**ADDENDUM NO. 1**

**CID 01-STILLHOUSE BRANCH WASTEWATER TREATMENT FACILITY  
IMPROVEMENTS**

**PROJECT NO.: 2-01590 | TWDB CWSRF NO. 73776**

**DATE OF ADDENDUM: MAY 24, 2023**

PM J. JENKINS  
 DESIGNED M. CLOUGH  
 DRAFTED TFG, PA  
 CHECKED J. JENKINS  
 PROJECT NO. 2-01590  
 DRAWING NO. **C-11**

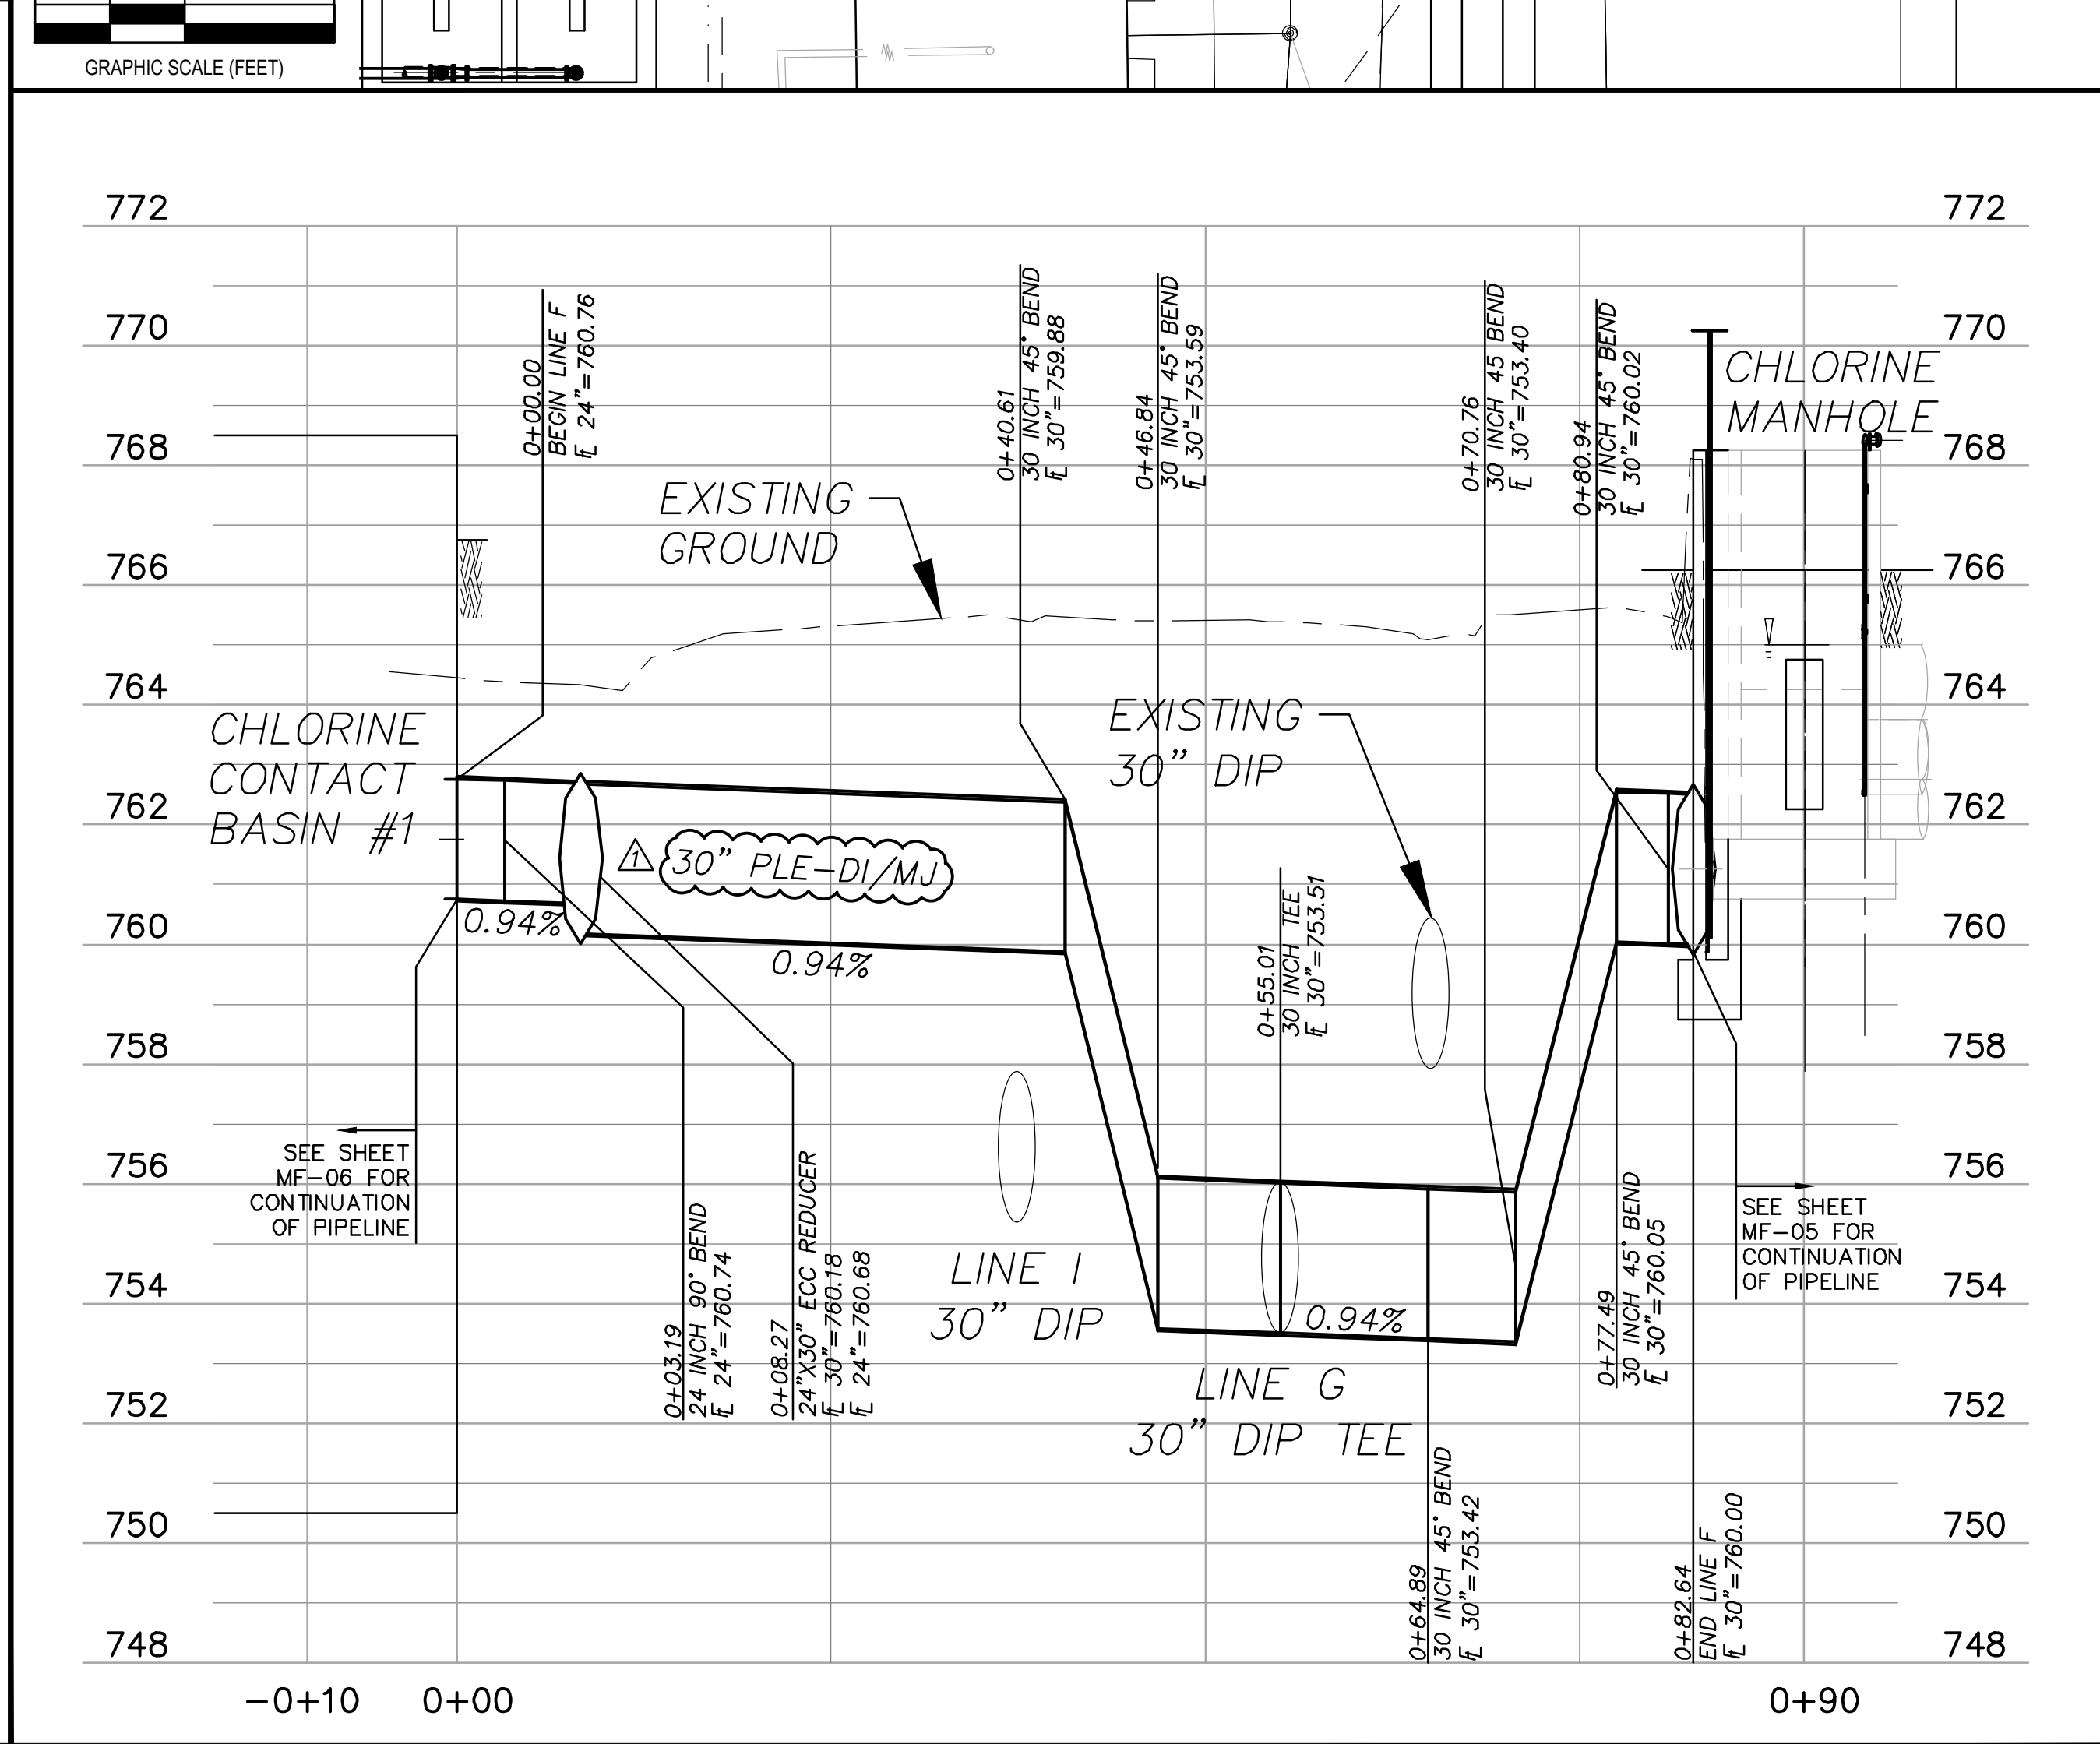
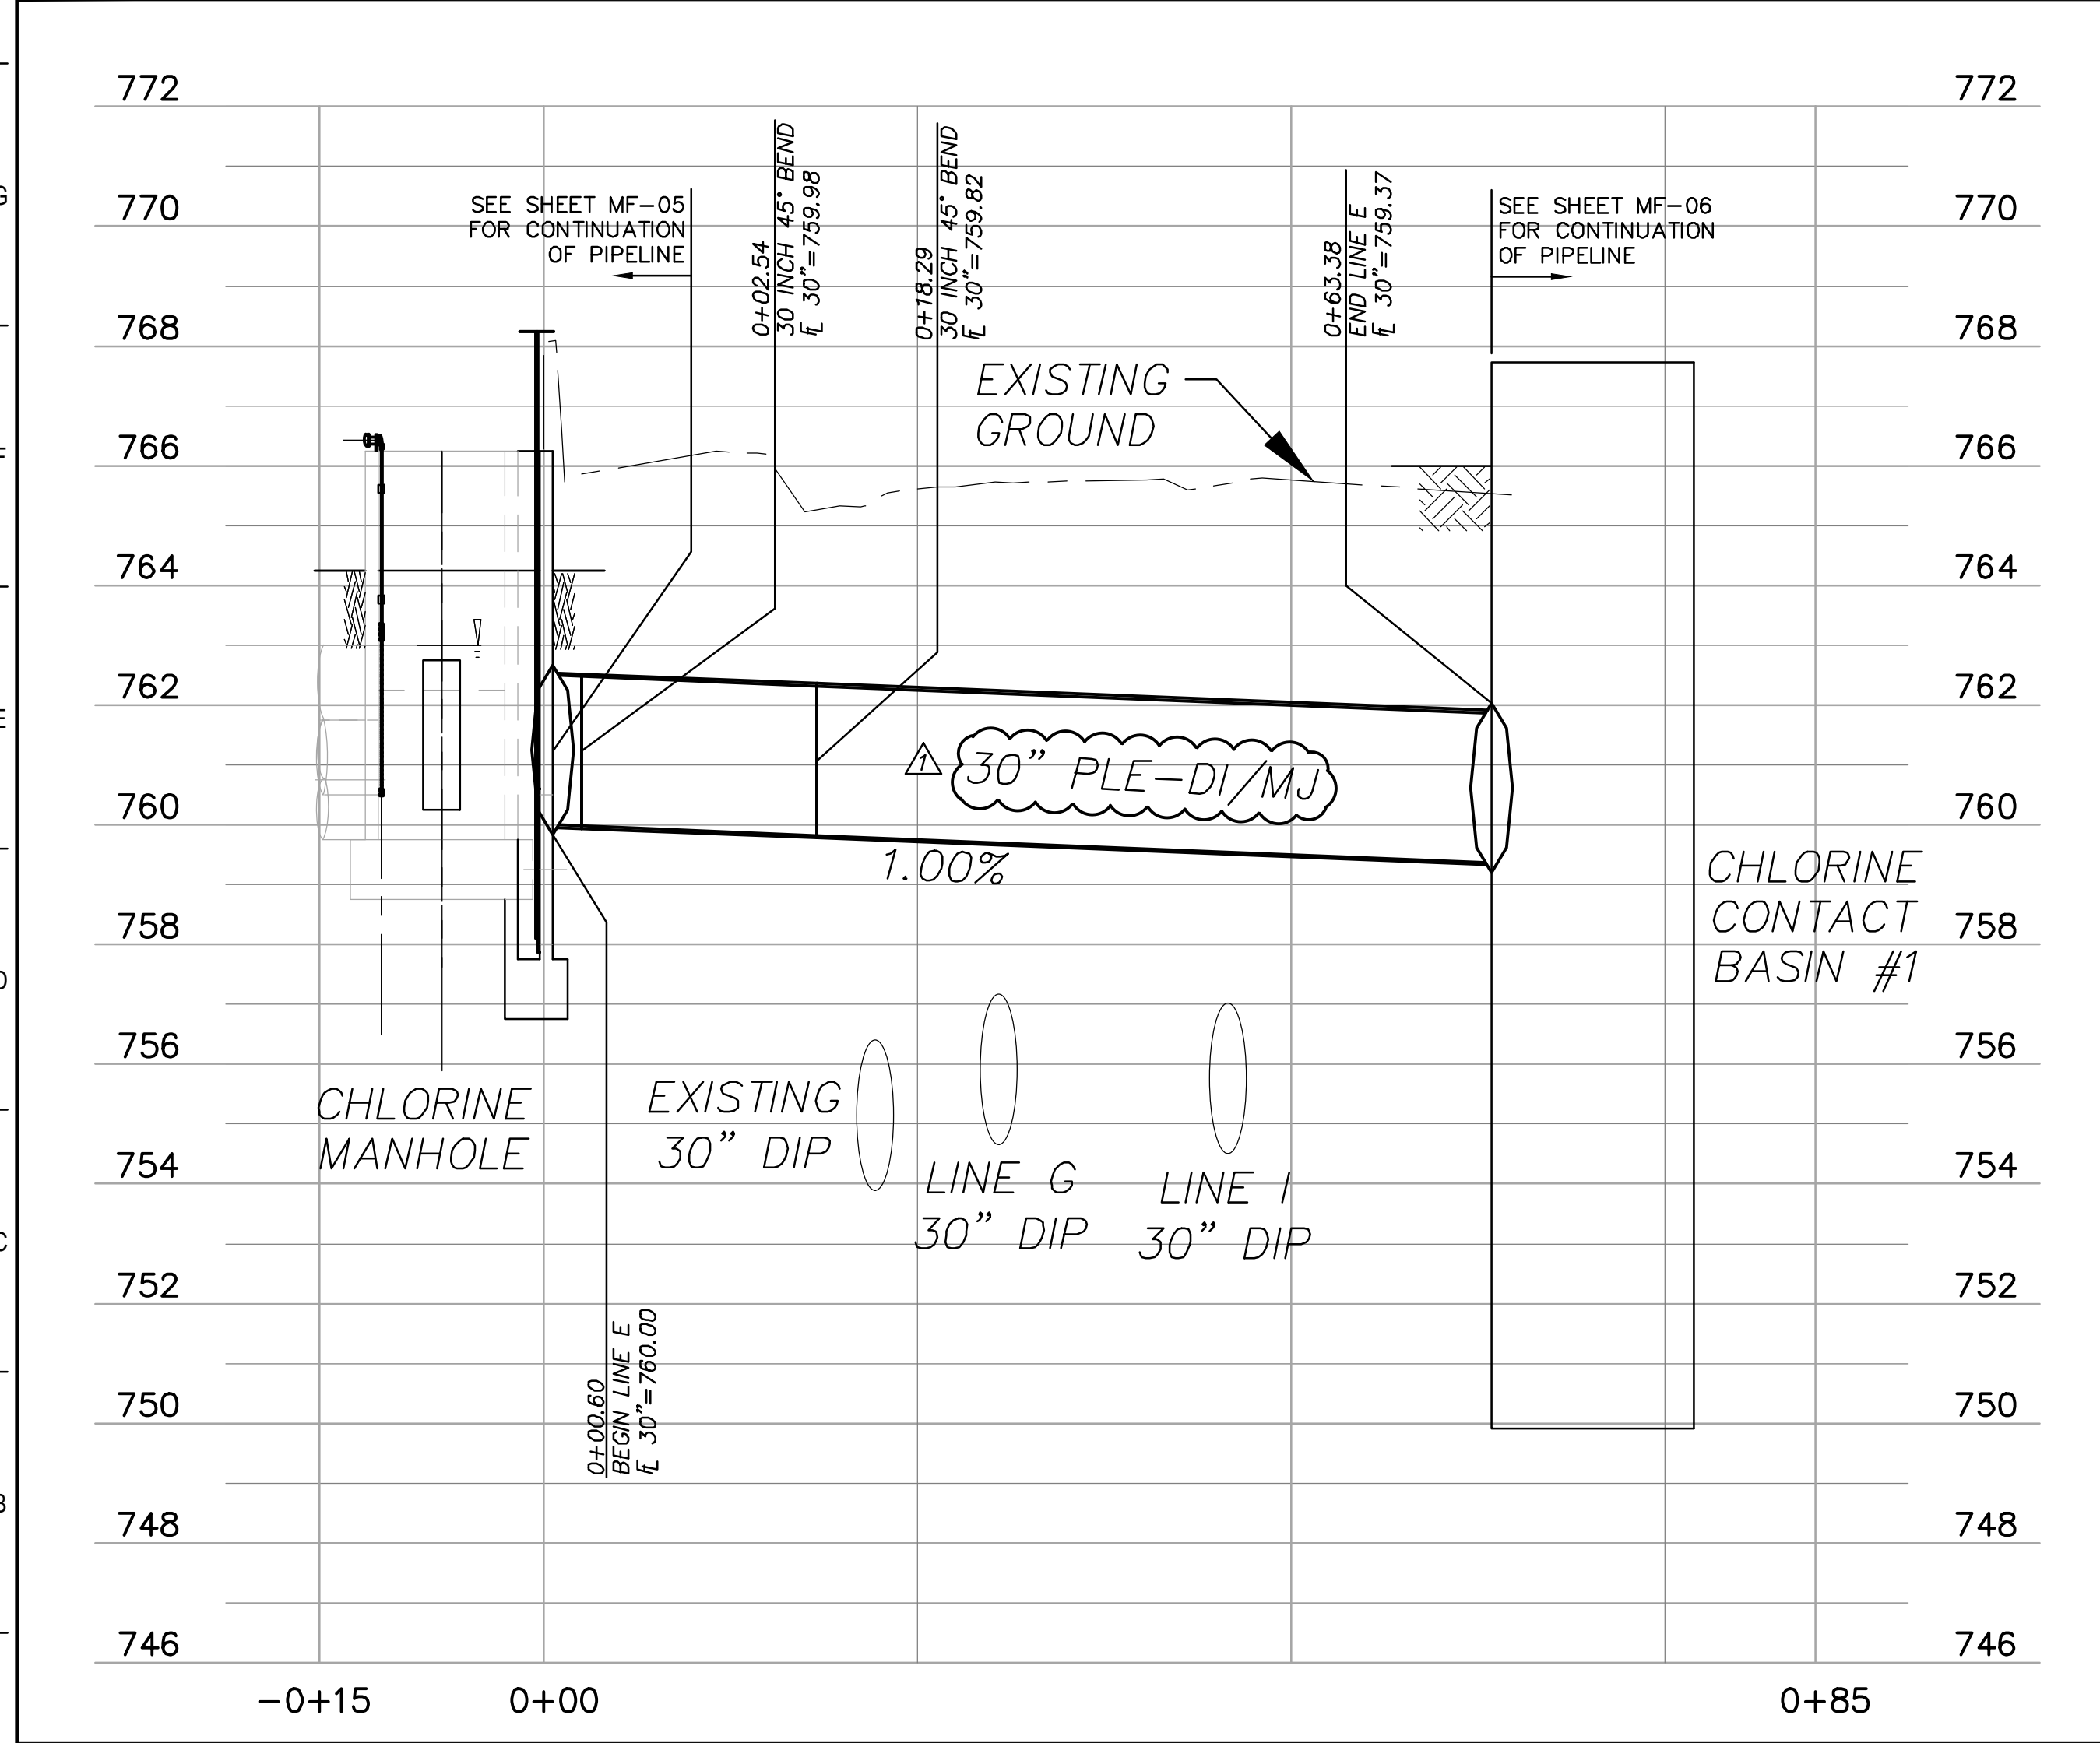
a. Sheets C-08 through C-17

REVISE yard piping to reflect the pipe labels on Sheet M-01 and Sheet M-02.
